Cameron Cove Cluster Subdivision

PART OF THE SOUTHWEST QUARTER OF SECTION 28, TOWNSHIP 6 NORTH, RANGE 2 WEST, SALT LAKE BASE AND MERIDIAN, U.S. SURVEY
WEBER COUNTY, UTAH
NOVEMBER, 2017

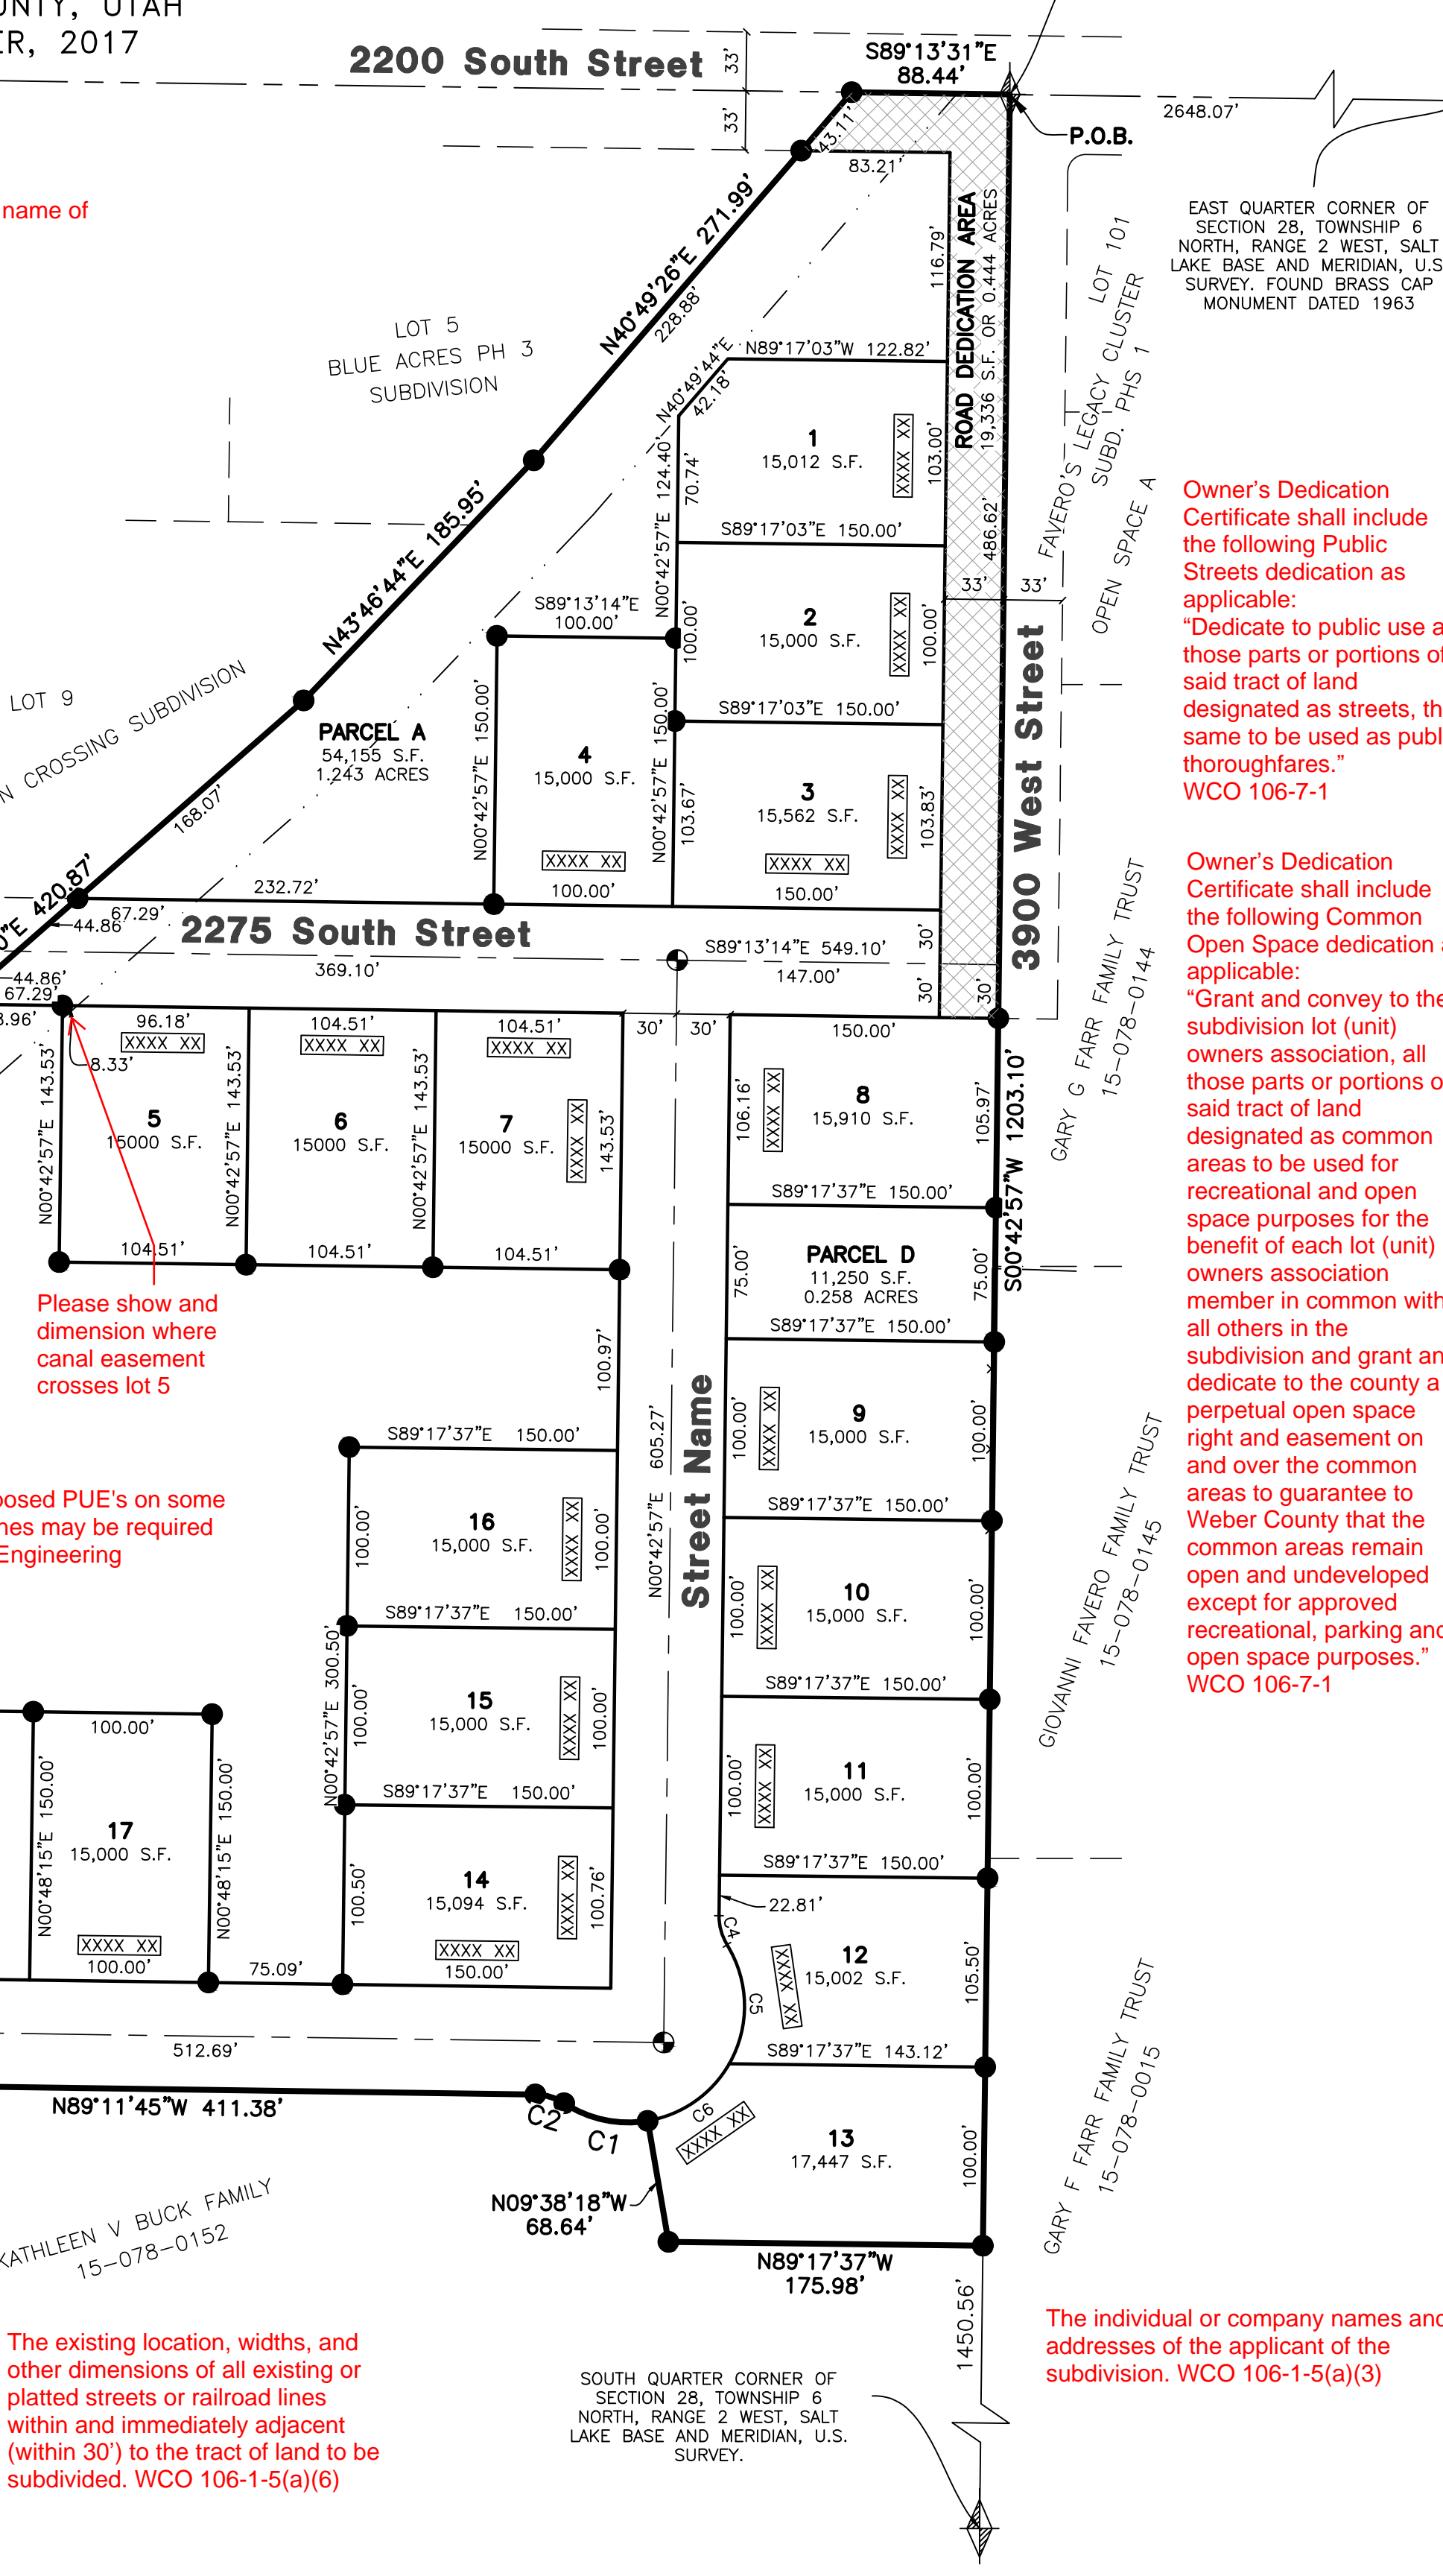
The plat shall have a detailed description of all monuments found and each one shall be referenced on the plat including the type, size, condition, and location in reference to the surface of the ground as well as a description or graphic depiction of the markings, date, agency, entity, or surveyor as inscribed on the monument. WCO 45-3-3(b)

The narrative explains and identifies the found monuments or deed elements that controlled the established or reestablished lines. UCA 17-23-17(4)(a)(iii) What was found and held to control ground locations of Malard Springs and Blue Acres?

Please add: ...located on the subject property entirely within proposed public rights of way and is to be vacated...

...to the northwest corner of Lot 21 Malard Springs Subdivision...
Subdivision called to does not exist.

The subdivision boundary corners, lot corners, and centerline street monuments shall be noted on the final plat in conformance with county ordinance. WCO 106-1-8(c)(1) County Ordinance requires that all lot corners be set. Per County Ordinance, lead plugs and washers may be set as a reference but not in place of the front corners. Show front corners to be set.

Calls to and along Blue Acres?

These lines from "Cameron Crossing Subdivision" are being shown as adjoining property lines when that subdivision does not yet exist. Please remove or change lintype with proper labels in the legend.

The existing location, widths, and other dimensions of all existing or platted land drains, culverts, watercourses, wetlands, streams, corridors setbacks, flood plain within and immediately adjacent (within 30') to the tract of land to be subdivided. WCO 106-1-5(a)(6)

Please show and dimension where canal easement crosses lot 5

Proposed PUE's on some lot lines may be required per Engineering

The existing location, widths, and other dimensions of all existing or platted streets or railroad lines within and immediately adjacent (within 30') to the tract of land to be subdivided. WCO 106-1-5(a)(6)

Camarren Cove Estates Subdivision already exist, please change name of proposed subdivision to something more unique.
